APPLICATION NO.	FILING DATE	FIRST NAMED INVENTOR	ATTORNEY DOCKET NO.	CONFIRMATION NO.
10/567,975	02/10/2006	Chojiro Kuriyama	10921.381USWO	5511
52835	7590	07/02/2007		
HAMRE, SCHUMANN, MUELLER & LARSON, P.C. P.O. BOX 2902 MINNEAPOLIS, MN 55402-0902			EXAMINER THOMAS, ERIC W	
			ART UNIT 2831	PAPER NUMBER
			MAIL DATE 07/02/2007	DELIVERY MODE PAPER

Office Action Summary

DETAILED ACTION

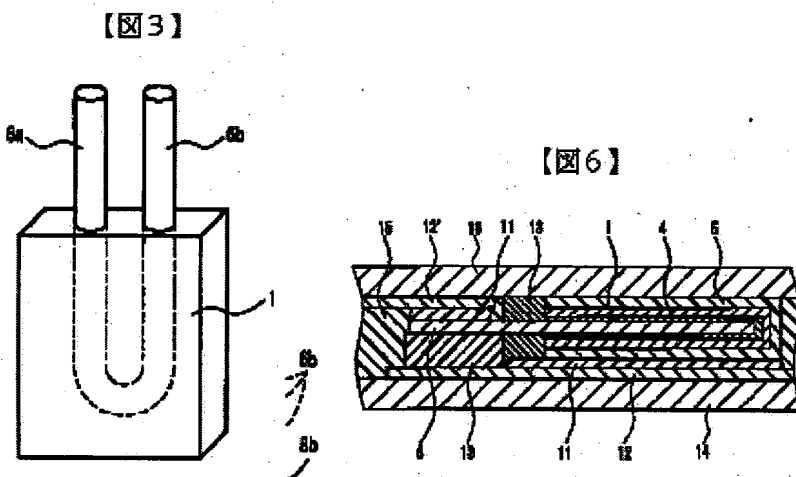
4. Claims 1, 3, and 10 are rejected under 35 U.S.C. 102(a) as being anticipated by Masanori et al. (JP 2003332173).

Masanori et al. disclose in fig. 3, a solid electrolytic capacitor comprising: a porous sintered body of metal particles ceramic particles; an anode partially inserted in the porous sintered body or conductive sintered body; second anode terminals provided by portions project from the porous sintered body; and a cathode formed on an obverse surface of the porous sintered toward the body, wherein circuit current flows from the first anode terminal toward the second anode terminal through the porous sintered body.

Regarding claim 3, Masanori et al. disclose the anode comprises an anode wire having opposite ends projecting from the porous sintered body; and wherein the first and the second anode terminals are provided by the opposite ends.

Regarding claim 10, Masanori et al. disclose the first anode terminal is higher in equivalent series inductance than the second anode terminal.

FIG. 3

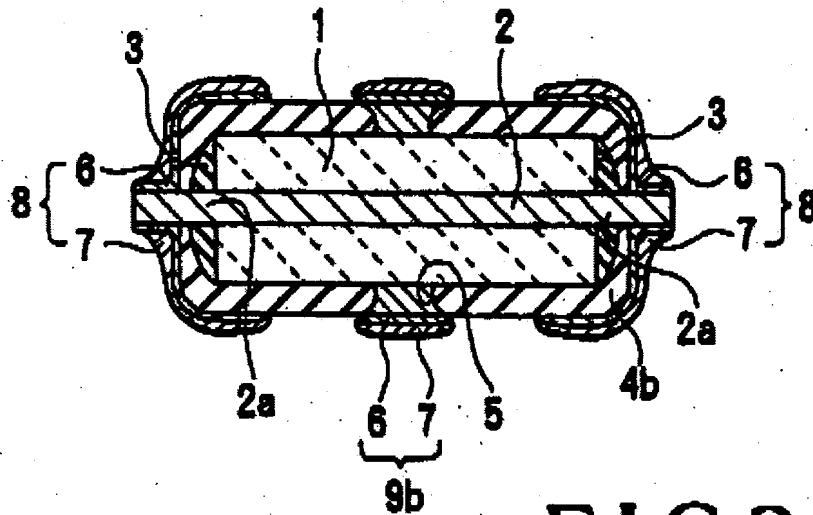
Taniguchi discloses a solid electrolytic capacitor comprising a porous sintered body of metal particles or conductive ceramic particles; an anode partially inserted in the porous sintered body; a first and a second anode terminals provided by portions of the anode which project from the porous sintered body; and a cathode formed on an obverse surface of the porous sintered body; wherein circuit current flows from the first anode terminal toward the second anode terminal through the porous sintered body (inherent feature). When the structure recited in the references is substantially identical to that of the claims, claimed properties or functions are presumed to be inherent.

Regarding claim 3, Taniguchi discloses the anode comprises an anode wire having opposite ends projecting from the porous sintered body; and wherein the first and second anode terminals are provided by the opposite ends.

Regarding claim 5, Taniguchi discloses the porous body is in a form of a flat plate.

Regarding claim 7, Taniguchi discloses the porous sintered body includes at least two side surfaces standing in a thickness direction; and wherein the first and the second anode terminals projected from two different side surfaces.

Regarding claim 8, Taniguchi discloses the porous sintered body is flat in section.

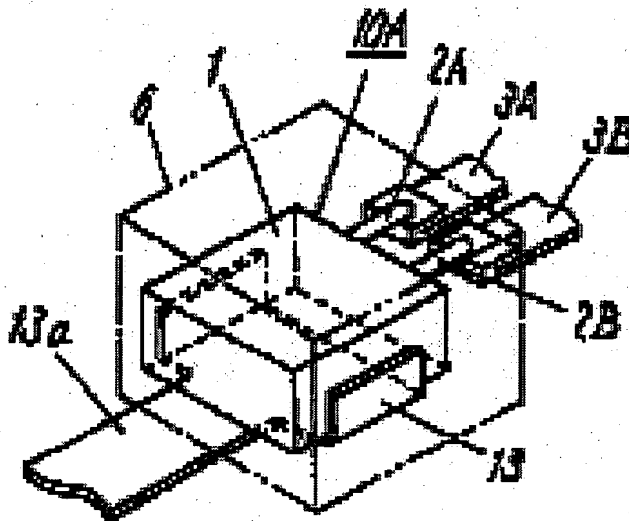
'774 discloses in fig. 6, a solid electrolytic capacitor comprising: a porous sintered body of metal particles or conductive ceramic particles (1); an anode (2) welded to the porous sintered body; a first and a second anode terminals provided by portions of the anode which project from the porous sintered body; and cathode formed on an obverse surface of the porous sintered body; wherein circuit current flows from the first anode terminal toward the second anode terminal through the porous sintered body.

'774 discloses the claimed invention except for the anode being partially inserted in the porous sintered body.

Edson et al. teach (paragraph 49) that anode wires can be partially inserted into sintered anode bodies of solid electrolytic capacitors.

It would have been obvious to a person of ordinary skill in the art at the time the invention was made to form the capacitor of '774 with embedded anode wires, since such a modification would eliminate the need to weld the anode wire to the compact.

Regarding claim 2, '774 discloses the anode comprises a plurality of anode wires (2A, 2B).

Regarding claim 5, '774 discloses the porous sintered body is in a form of a flat plate.

Regarding claim 6, '774 discloses the porous sintered body includes a side surface standing in a thickness direction; and wherein the first and the second anode terminals project from the side surface.

Regarding claim 9, '774 discloses the porous sintered body is columnar or prismatic.

Regarding claim 11, '774 discloses first and second cathode terminals electrically connected to the cathode, wherein circuit current flows from the first cathode terminal toward the second cathode terminal through the cathode (see fig 4).
